UNITED STATES PATENT AND TRADEMARK OFFICE

APPLICATION NO.	FILING DATE	FIRST NAMED INVENTOR	ATTORNEY DOCKET NO.	CONFIRMATION NO.
10/664,294	09/17/2003	Jeffrey Allan Rock	GP-301429	4556

Office Action Summary	Application No. 10/664,294	Applicant(s) ROCK, JEFFREY ALLAN	
	Examiner Raymond Alejandro	Art Unit 1745

DETAILED ACTION

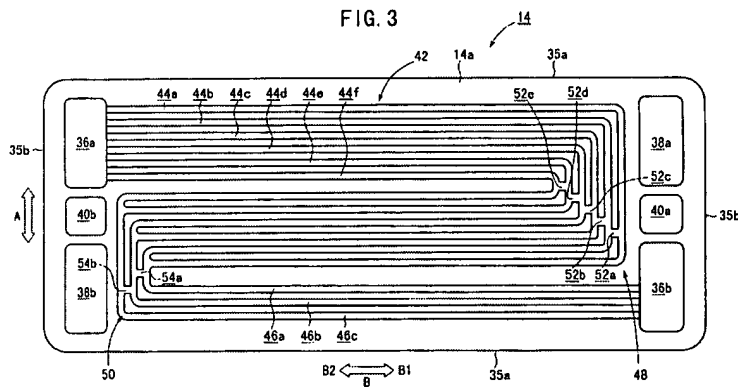
Figure 3 below depict the flow field comprising gas inlets 36a and 38a, and gas outlets 36b and 38b for oxygen containing and fuel gases, respectively (COL 3, lines 25-35). Further, as

evident from the **Figure 3**, the flow channels have the so-called medial legs intermediate said inlet and exit legs (*the bent sections of the flow channel*).

FIG. 5

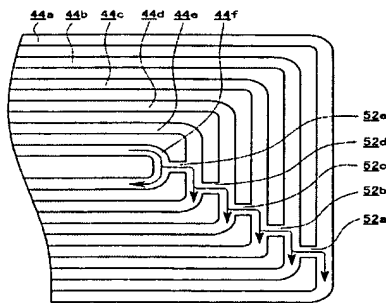
Figures 5-9 below contains a depiction of flow restrictors provided by Fujii et al in the flow field plate. Although they have been identified as communication passages, they also act as flow restrictors:

FIG. 6

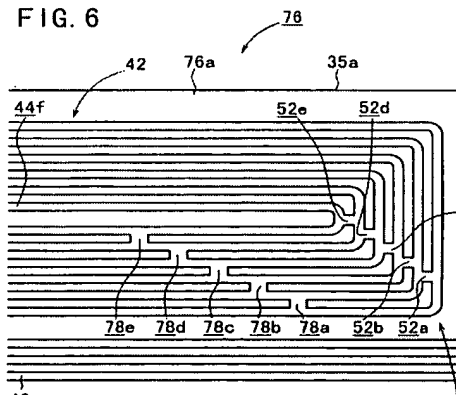
As apparent from **Figures 3 and 6**, the flow distribution plate include a section of non-serpentine channels and another section of serpentine channels (*the channel section turning one way and another*) (See FIGURES 3-4).

Figure 6 also illustrates, as a whole, channels configured with different turning points.

FIG. 8

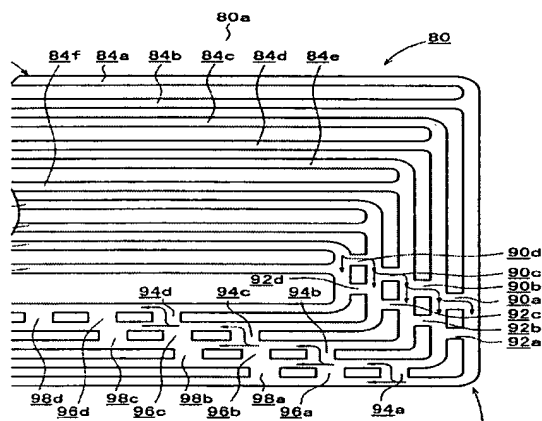
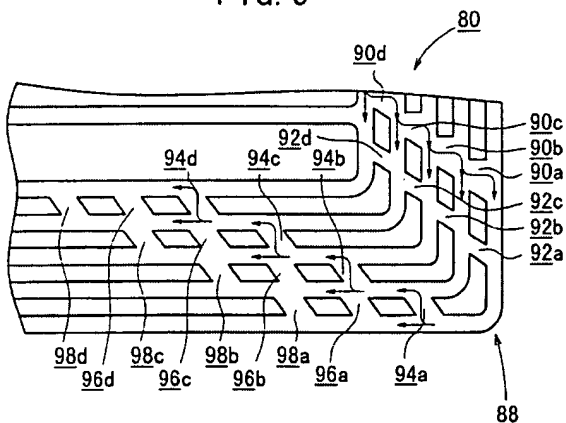
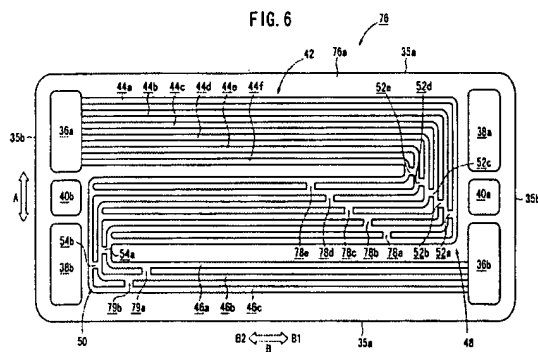
Accordingly, pressure differences associated with the specific communication passages are present in the flow field plate. Significant loss of pressure of the fluid passing through the channels will occur at the communication passages.

FIG. 9

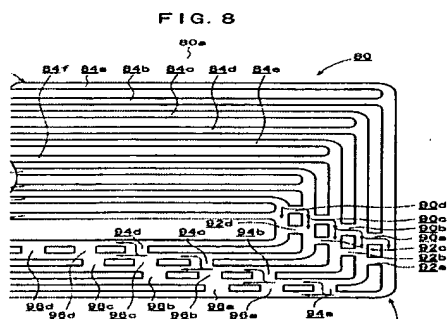
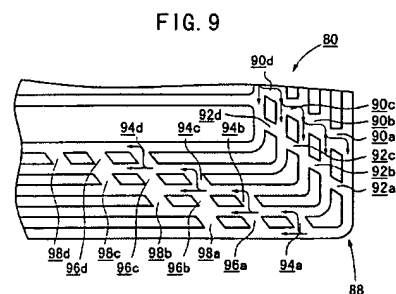
Figure 9 below illustrate flow constriction having different cross-sectional areas along with a tortuous section which includes both the cross-sectional communication passages and the flow bents (See Figures 8-9):

FIG. 3

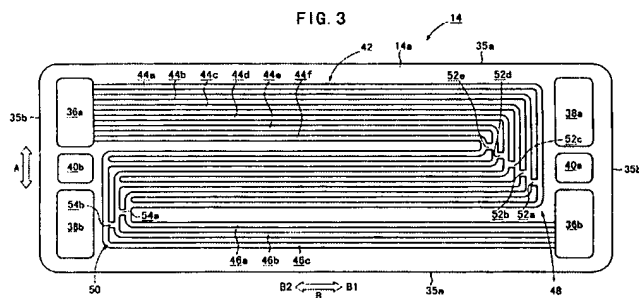
Illustrated is inlet 36a and ports for the flow passage grooves:

FIG. 5

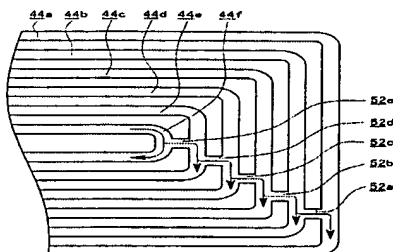
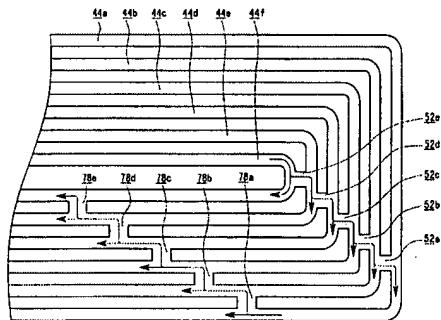
Figures 5 and 7 below specifically depict the bifurcation mid-sections:

FIG. 3

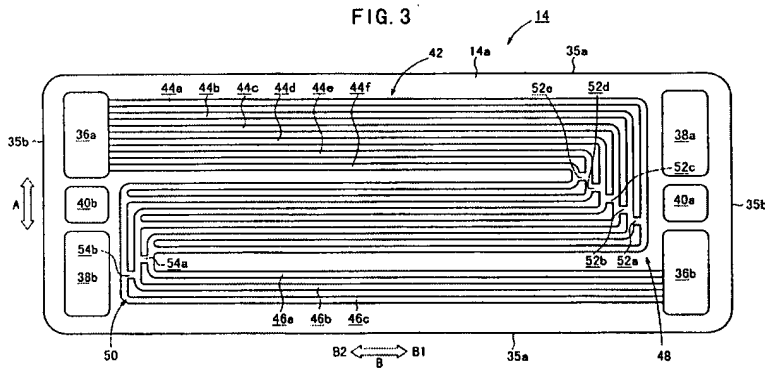
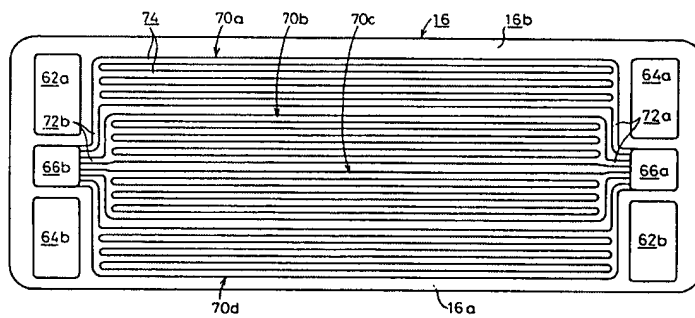
Figures 3-4 below depict the flow field comprising the branched midsection comprising the branches.
